**6F50/6F55 TRANSMISSION—SLIP/NEUTRAL OUT—
5TH GEAR START FROM STOP—BACKUP CAMERA
ON IN DRIVE—BUILT 3/13/2009-6/30/2010**

TSB 13-5-27

This article supersedes TSB **13-4-2** to update Service Procedure

Figure 1 - Article 13-5-27

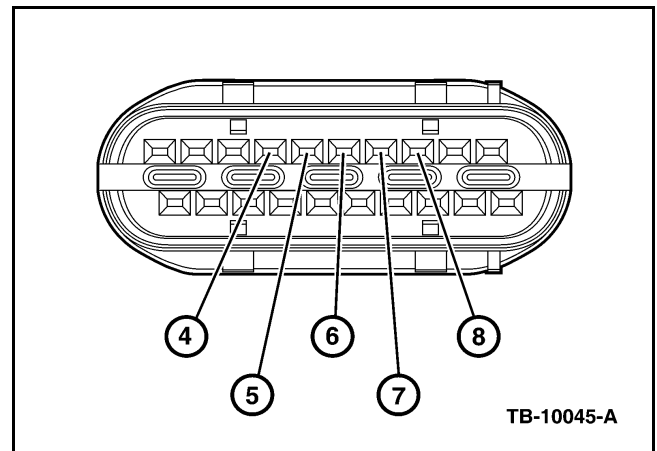
1. With brakes applied, engine off, key on, move the shifter to low gear (L or M) position.
2. Turn key off.
3. Disconnect connector C168 from the transmission.
4. Measure the resistance between the transmission connector pins:
 - 8 and 4
 - 8 and 5
 - 8 and 6
 - 8 and 7
 - a. The top row of the transmission's pins are numbered 1-10 from left to right. (Figure 1)

- b. If any of the four measurements are above 5 Ohms, proceed to Step 5.
 - c. If all measurements are within specification, this article does not apply. Refer to the appropriate Workshop Manual (WSM) Section for diagnosis and repair.
5. Replace the TR sensor. Refer to the WSM, Section 307-01.
 - a. Use only essential special service tool (ESST) 307-696 to remove the retaining pin that holds the TR sensor in the transmission case.
 - b. Attach ESST 307-696 to the transmission case with two (2) pan bolts.
 - c. Slide the cylinder over the head of the retaining pin and tighten the nut on the threaded shaft to pull the cylinder up and retaining pin out of the transmission case. (Figure 2)

Figure 3 - Article 13-5-27

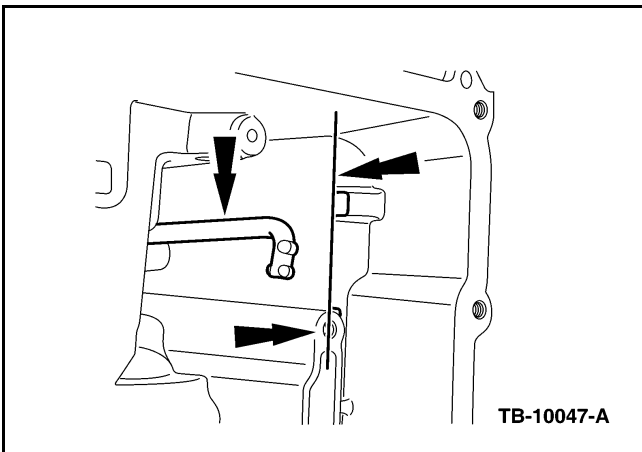
- d. Do not allow the park pawl actuator rod to become disengaged from the park pawl and the abutment. Keep the end of the park pawl actuator rod behind the machined valve body mating surface of the transaxle case. If the park pawl actuator rod becomes disengaged from the park pawl and the abutment, transaxle removal and disassembly is required to install the actuator rod. (Figure 3)
